Title: Advisory Committee on Reactor Safeguards
Westinghouse AP1000 DCD: Open Session

Date: Wednesday, December 1, 2010

7 SUBCOMMITTEE ON THE WESTINGHOUSE AP1000 DCD

AP1000 Reactor Coolant Pump Flywheel Action #4 Closure

Flywheel Configurations

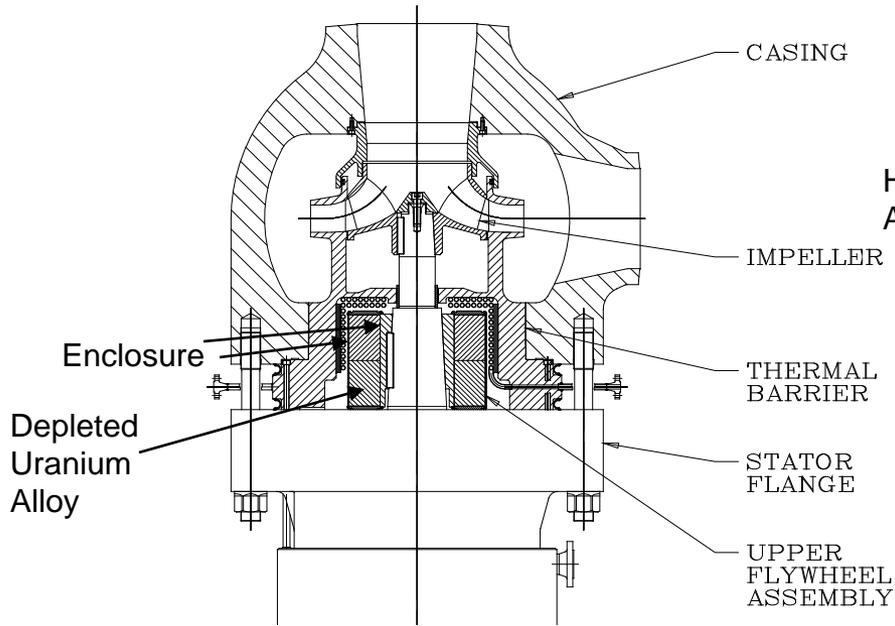
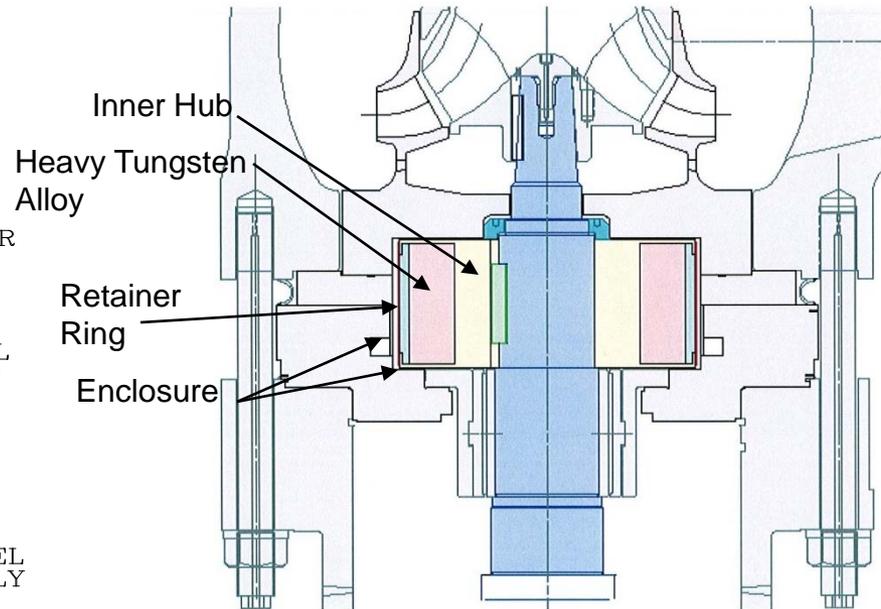
- **High Density Flywheel Material Change – Depleted Uranium to Tungsten Heavy Alloy**
 - Increase in Required Inertia - As the RCP Design was Finalized, Friction Losses Increased Due to Increased Power Requirements, Detailed Loss Calculations, etc.
 - Depleted Uranium was Structural Component – Increase in Inertia Required Increase in Diameter Which Resulted in High Stress Levels
 - Evaluated Alternate Materials – Tungsten Heavy Alloy
 - Advantages of Tungsten Heavy Alloy – Multiple Suppliers, Known Material Properties/Fracture Toughness (ASTM), Volumetric Examinations Standard, No Environmental/Health Issues, Owning/Handling Not Regulated
 - DCD Revision 17 Flywheel Configuration Changed Such that High Density Material is Not a Structural Part
 - Retainer Ring Holds Tungsten Heavy Alloy Segments, Only Structural Components are Ring and Inner Hub

- Flywheel Enclosure
 - Change from Alloy 690 to Alloy 625
 - Advantages of Alloy 625 – Lower Coefficient of Thermal Expansion (Reduces Stresses in Enclosure); Higher Yield Strength; Easier to Weld
- Retainer Ring
 - DCD Revision 17 – 18 Ni Maraging Steel for High Strength
 - Flywheel Mockup for Manufacturability and Demonstrate Balancing
 - Cracked Retainer Ring
 - Hydrogen Embrittlement/Stress Corrosion Cracking
 - Retainer Ring Material Change Included in Response to RCP RAI in May 2009
 - Ring Changed to 18Cr-18Mn
 - Material Developed for Retainer Ring Applications in Generators Because of Cracking in the Materials in Use (18Mn-5Cr)
 - Not Susceptible to Corrosion or Hydrogen Assisted Stress Corrosion Cracking
 - Lower Strength Requires Thicker Retainer Ring, Reduces Tungsten Alloy Mass
